FIFTH & UNION | RAINIER SQUARE REDEVELOPMENT  
Early Design Guidance Submittal #2

PROJECT #3017644

July 25, 2014

This document has been prepared in response to the Early Design Guidance of the Downtown Design Review Board, as published in minutes of the meeting held on June 17, 2014. In that meeting, priority design guidelines were identified along with recommendations of the Board.

View of Open Space Adjacent to Existing Rainier Tower

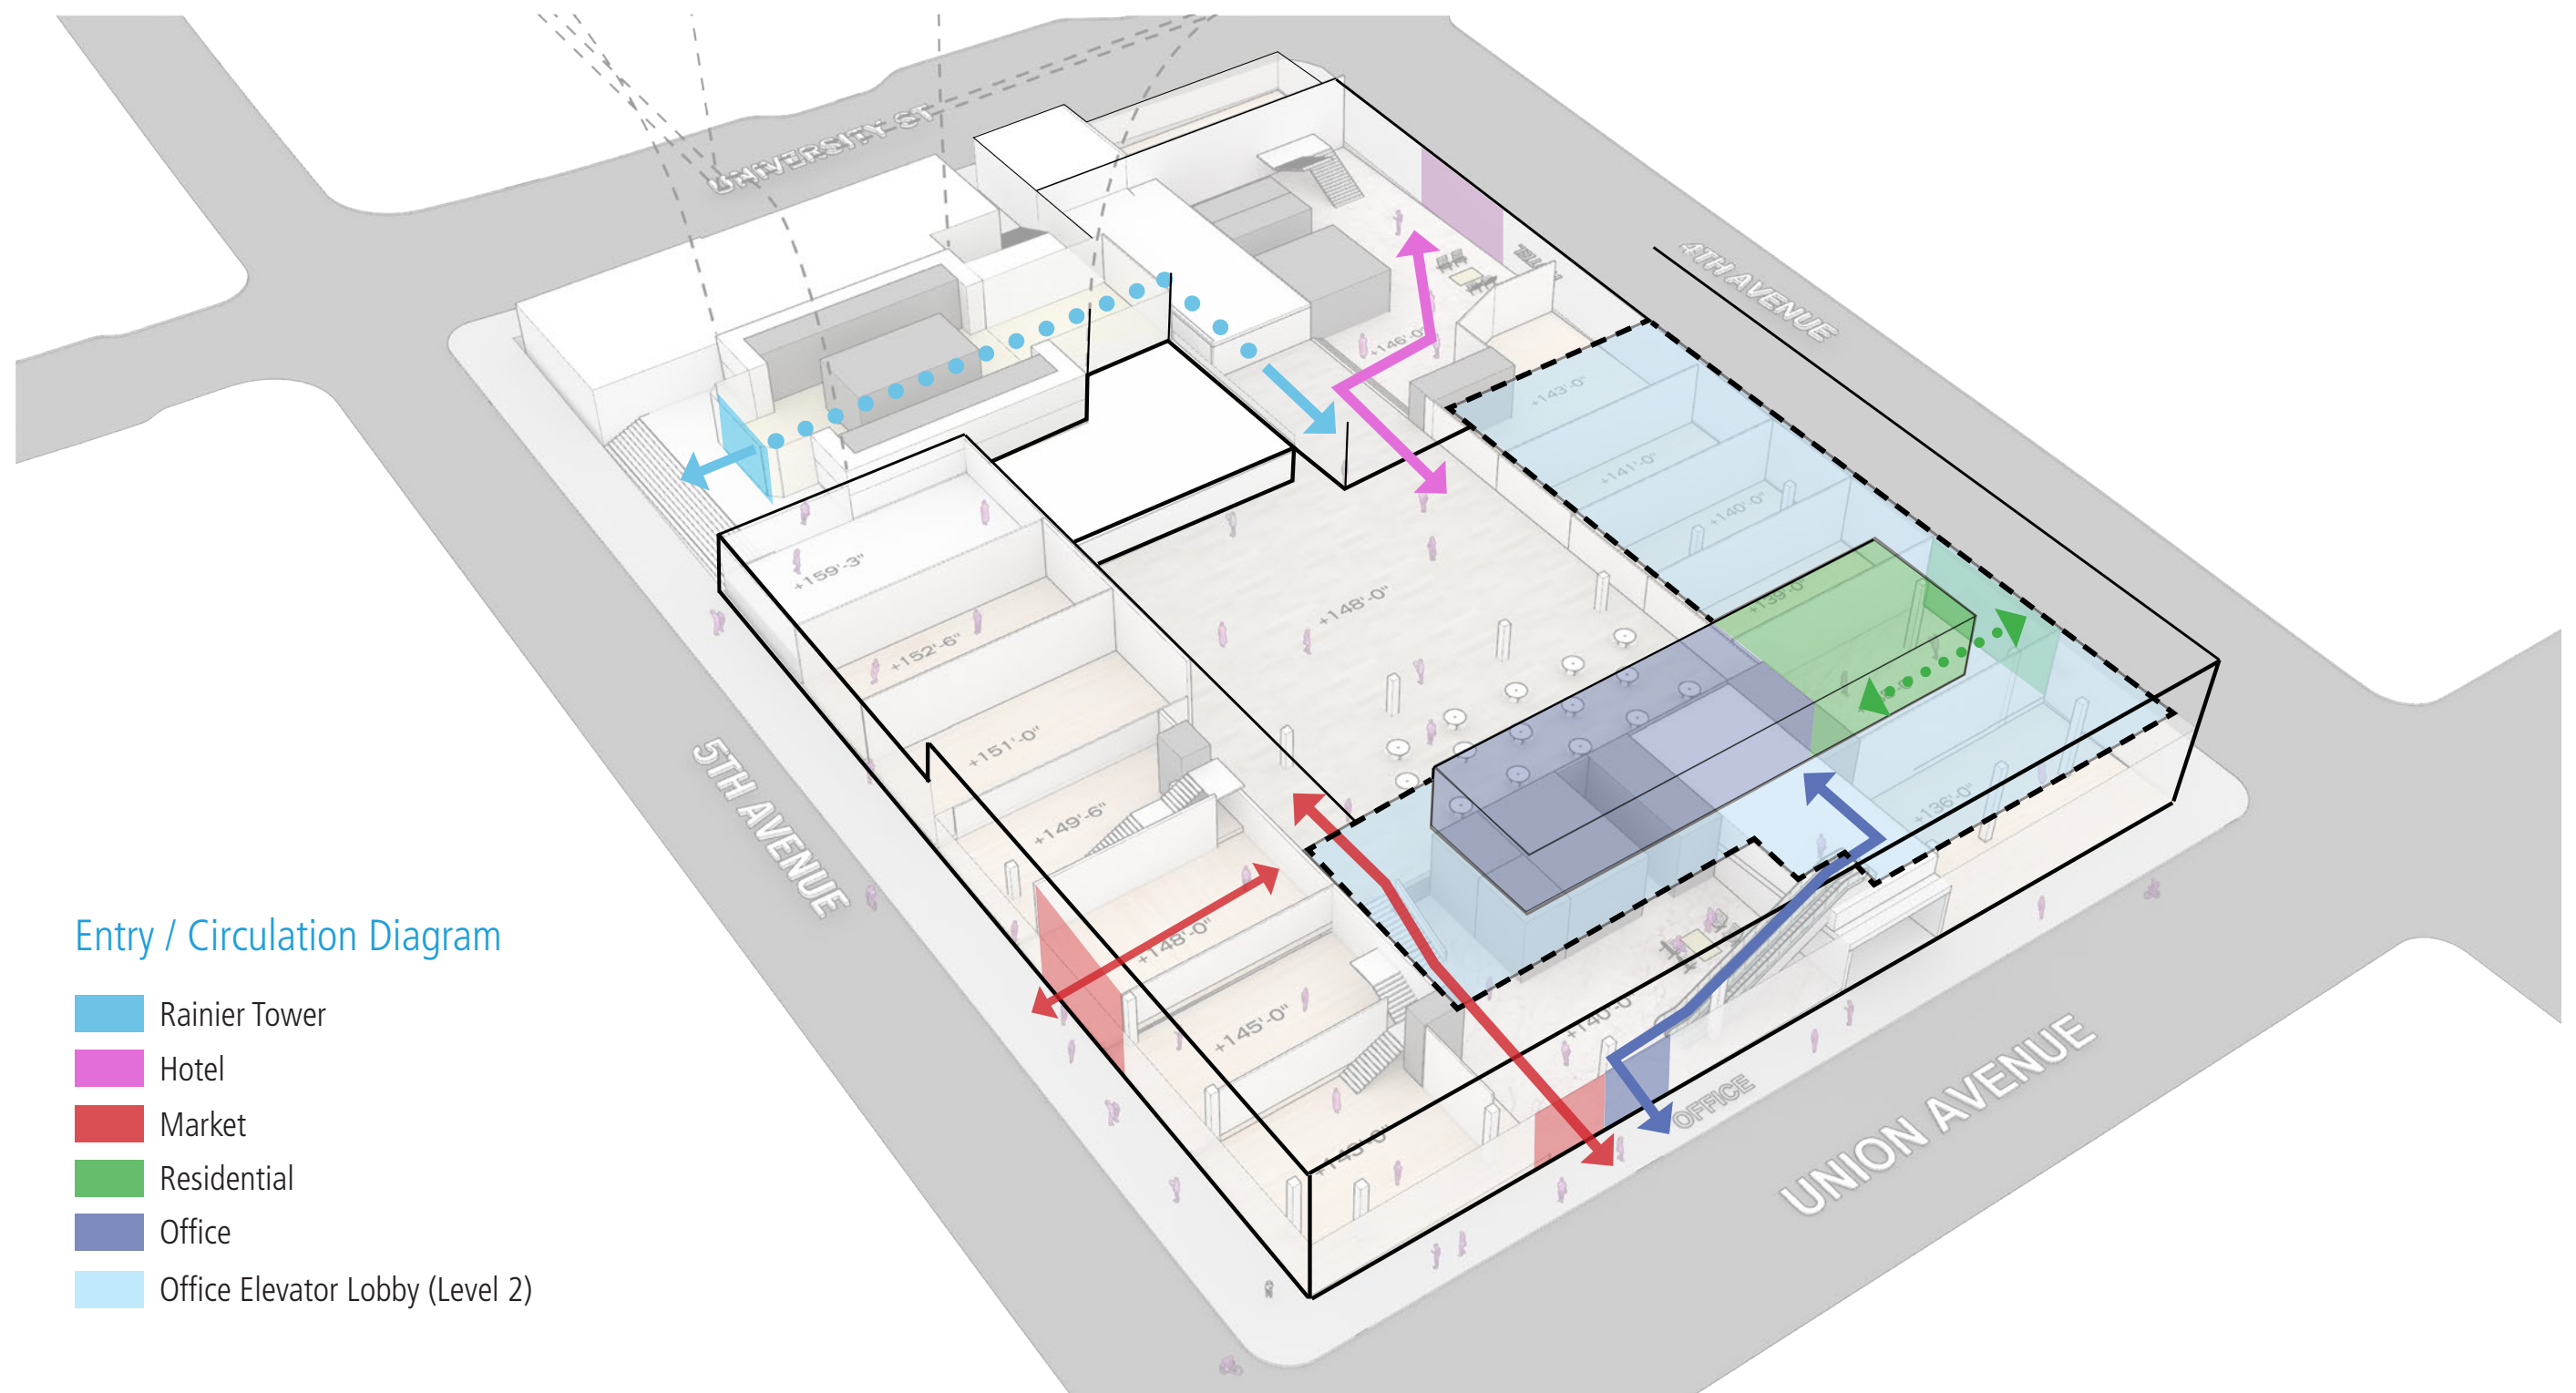
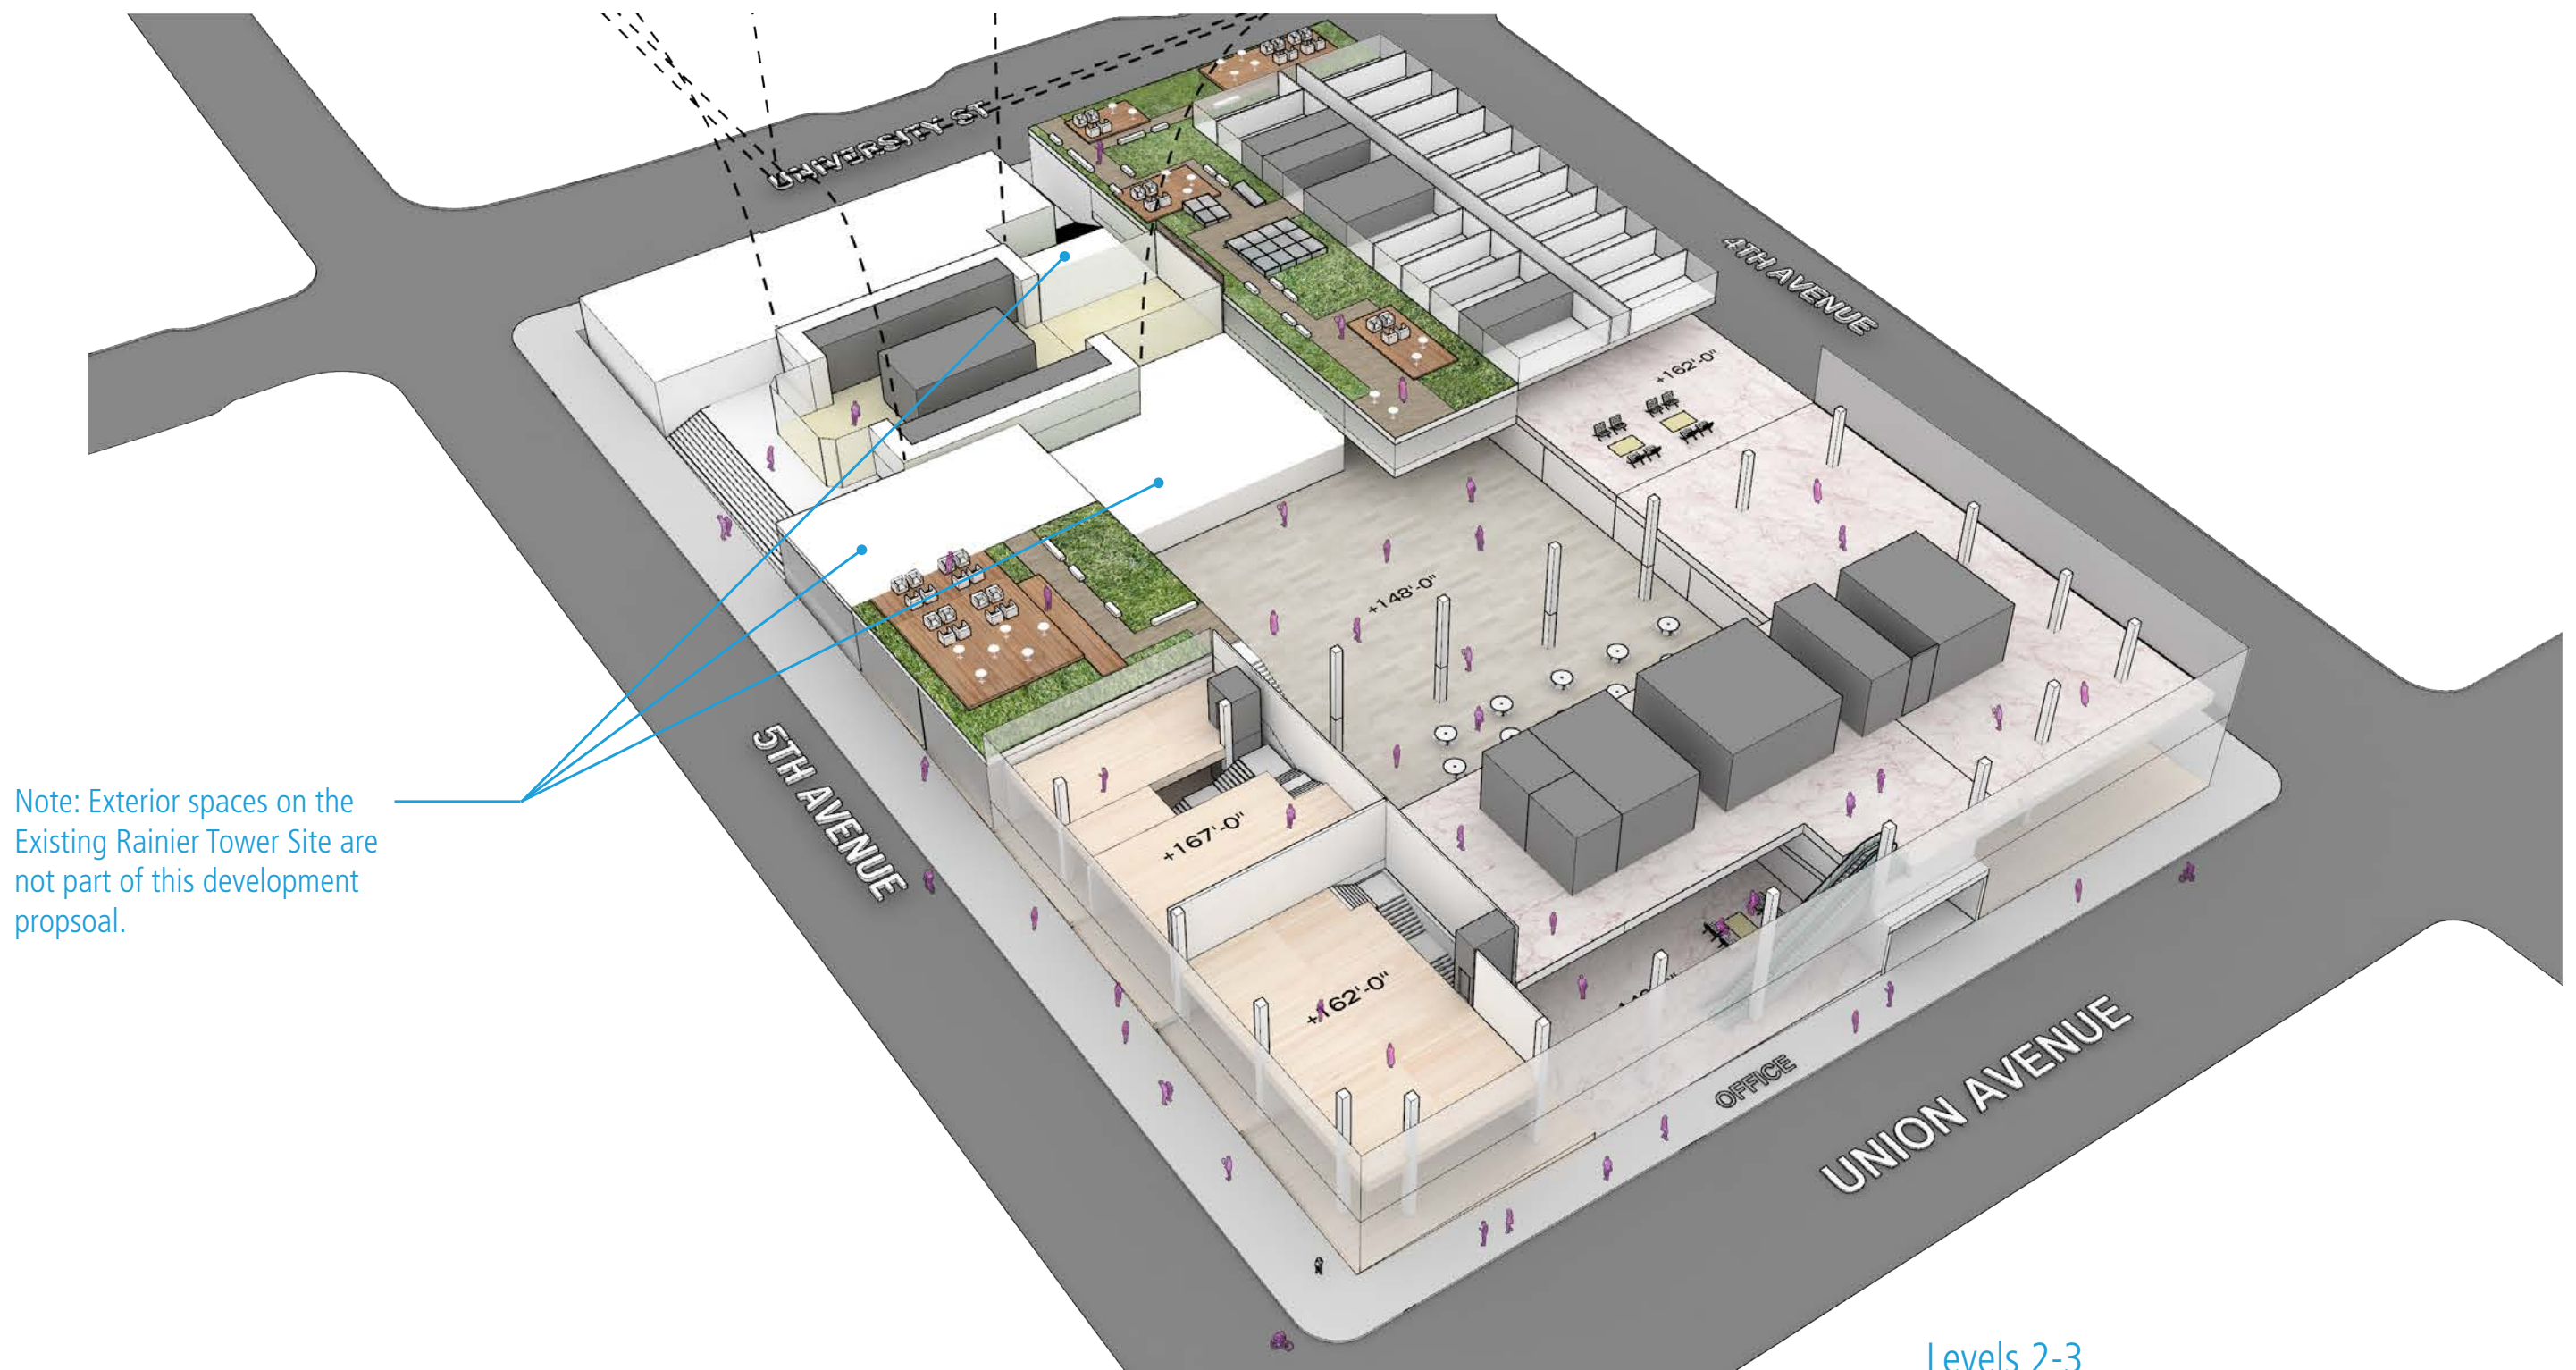
The desire for a coherent spatial arrangement of the masses at the lower levels or pedestrian realm of the complex corresponds to a second Board interest---that open space, whether private, public or a mix, has an outward presence at or near the streetscape. The applicant could consider the placement of open space at street level as an entry plaza(s) or above the plinth to exert itself in more compelling ways upon the pedestrian experience than the green swaths illustrated (p. 45) in the EDG booklet. Interstitial or negative space introduced by Rainier Tower's idiosyncratic base ought to be complemented by the massing of the new structures. The insertion of new volumes can serve to expand and shape this space into a definable open area. By giving the podium of the Rainier Tower breathing room, the development can celebrate a significant Seattle structure, supplements its visual dynamism and creates a meaningful space that defines the lower realm where the three major buildings meet.

Open space provided at the lower levels of the proposed development has been designed to leverage the unique features of the site's urban context. Open space will be aggregated at the base of the new development to create a series of open spaces envisioned as "lifted urban gardens", providing important visual connection from the pedestrian realm at street level to the sculptural base of Rainier Tower as well as to the light, air, and activity occurring at the new "plinth". A retail-oriented, glass-ceilinged central atrium space in the new development will also afford dramatic views of Rainier Tower and the surrounding context. As discussed in the response to guideline A-1, the massing of the office / residential tower and the hotel have both been adjusted to respond directly to guidance received from the board.

This open space will provide a unique sense of place, to respond and interact with Rainier Tower, and to enhance the downtown urban environment.

Concavity of Rainier Tower 's Base Inspired Proposed Tower's Form

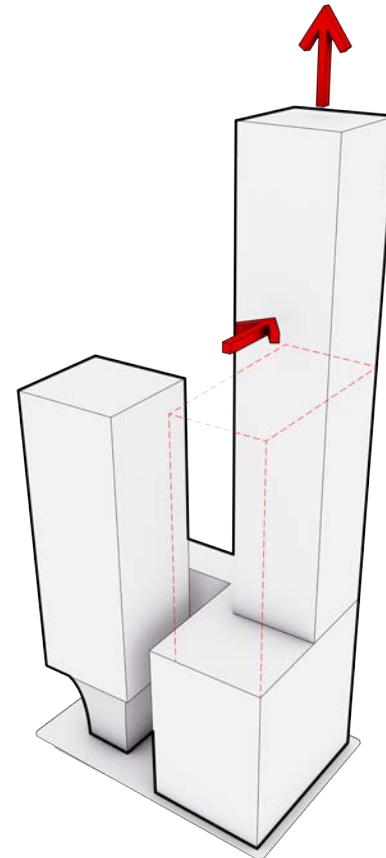
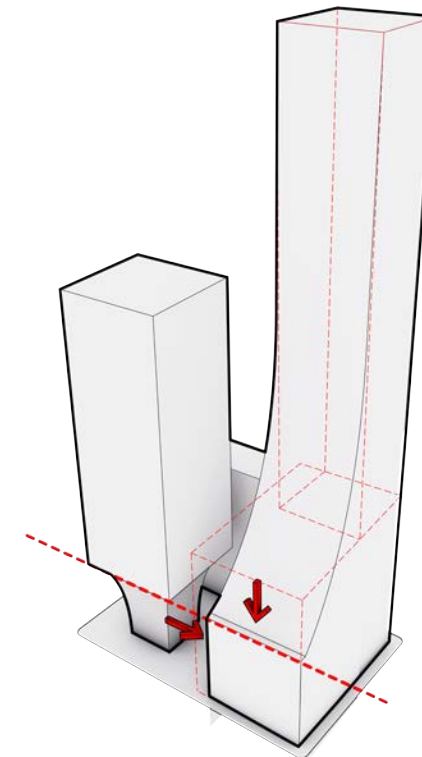
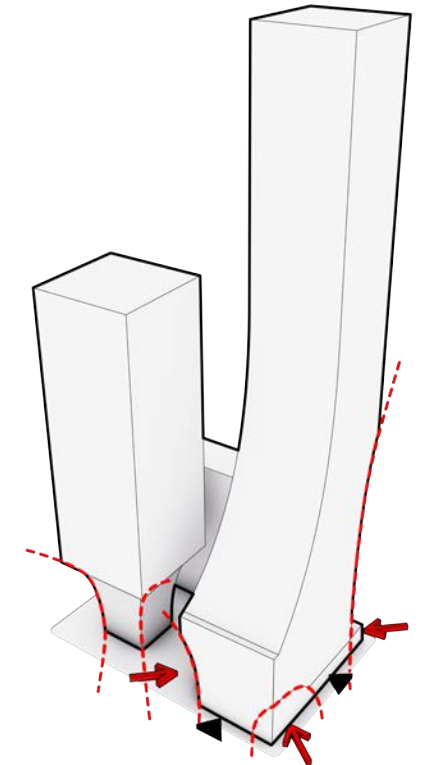
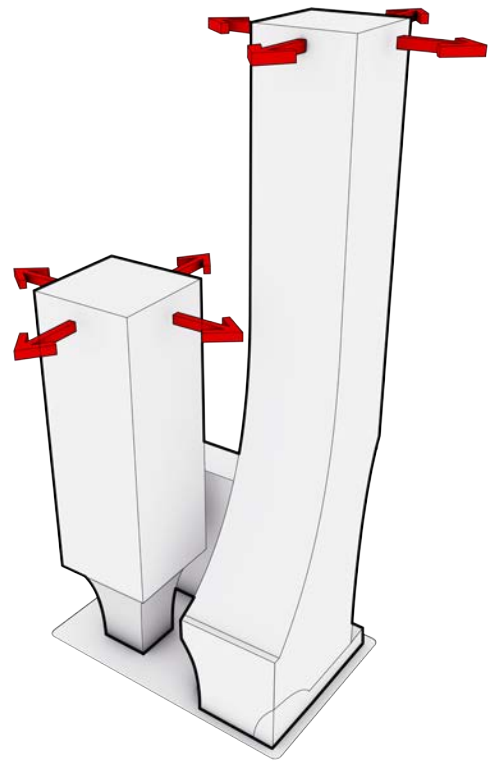
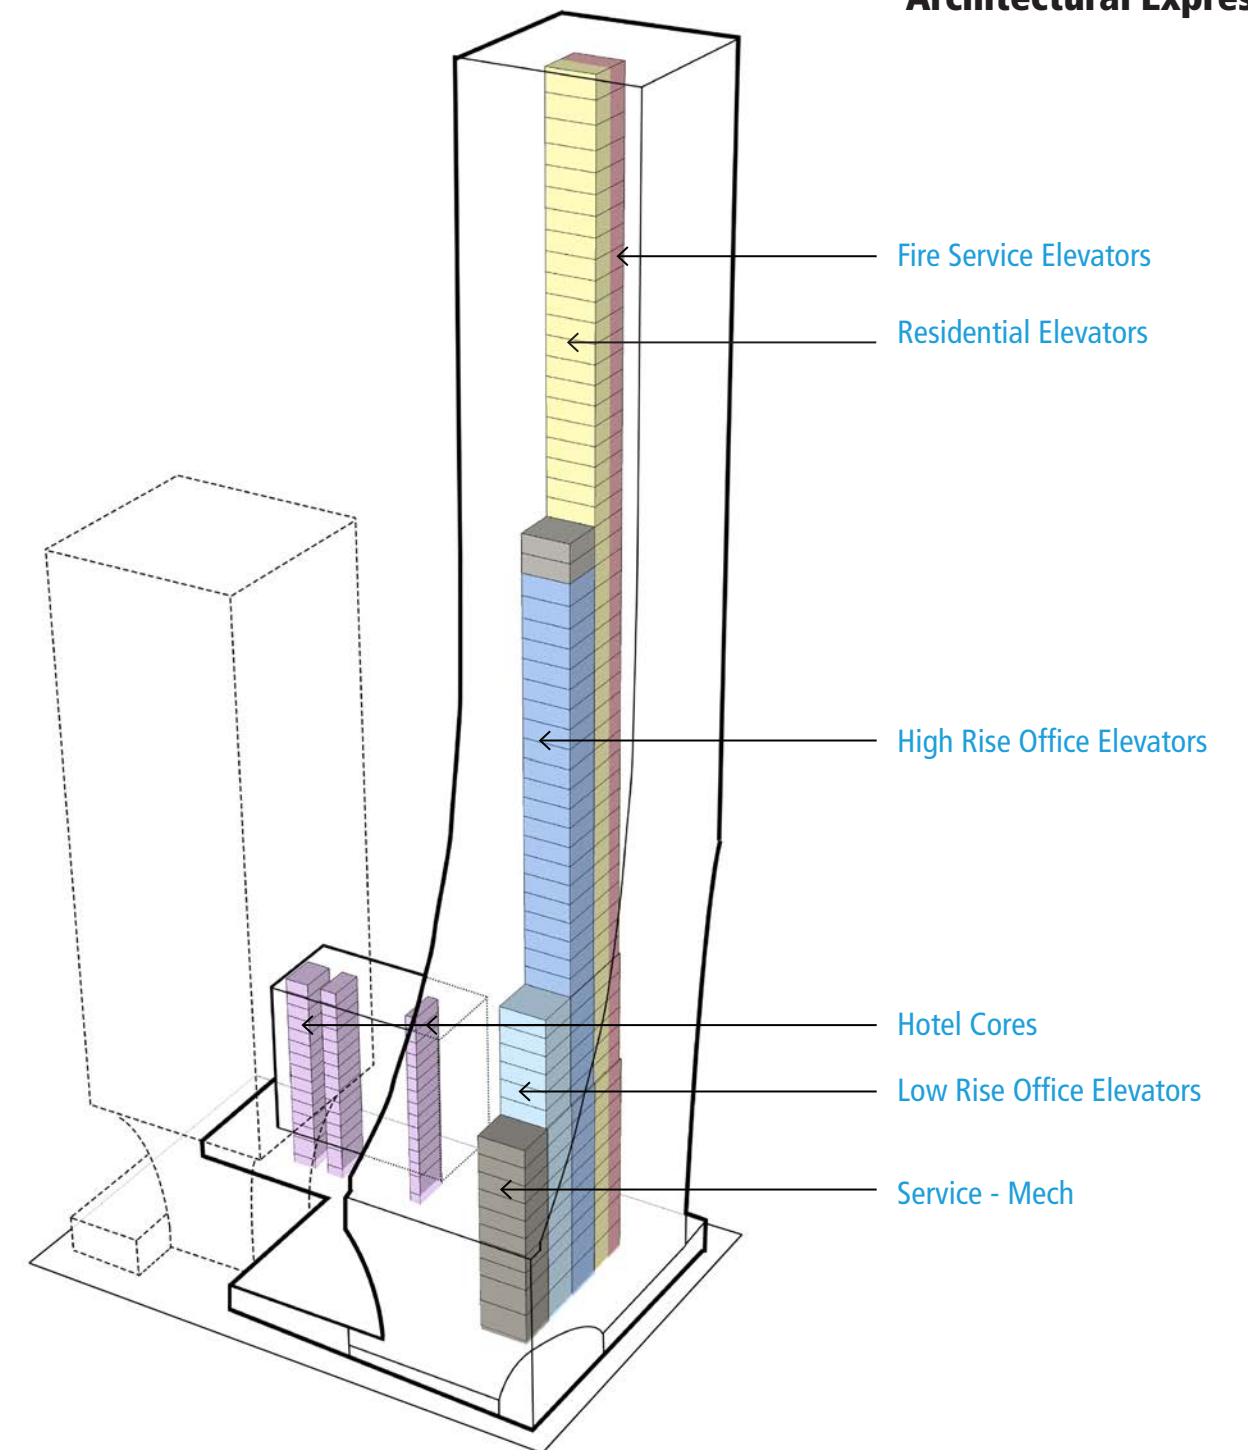
The concavity of Rainier Tower's base provides the design motif for the proposed tower's form. The architect's inversion of the form, a broad base tapering upward to the shaft, creates a visual reference. At the next meeting, the Board would benefit from a clearer understanding of the compelling reasons for the tiered or stepped building mass. Consider beginning the steps or tiers closer to the pedestrian level. The Board noted that this mid-section of the building has little or no engagement with the form that influenced it.

The massing for the office / residential tower is derived from the interaction between urban context, site constraints, functional program requirements and generative formal concepts. Stepping or sloping back the upper levels of the tower, as a formal gesture, responds to the local context of the block and the desire to preserve light, air, and views to and from both towers as well as within the broader context of this dense urban neighborhood. The functional program follows a logical progression from service at subgrade levels, pedestrian-oriented retail at street level, the office levels in the midsection of the tower, culminating with residential program at the upper levels. This program transition reinforces and complements the formal gesture of the tower as part of the urban realm. Building systems and services also follow in a logical and efficient sequence while supporting a graceful, complementary formal relationship between the two towers on the block.

The design has been specifically modified at the pedestrian levels along Fifth Avenue by "carving away" some of the lower façade in a manner reminiscent of Rainier Tower's base, opening up views to the open spaces in the interior of the block as well as to the base of the existing tower. Furthermore, the beginning of the sloped section of the tower's midsection has been set back from the façade by approximately ten feet to reinforce the inverse and complementary relationship between the negative space of Rainier Tower base and the street wall of the new development along Fifth Avenue. This creates yet another opportunity for open space as part of the overall spatial composition at the lower levels of the development.
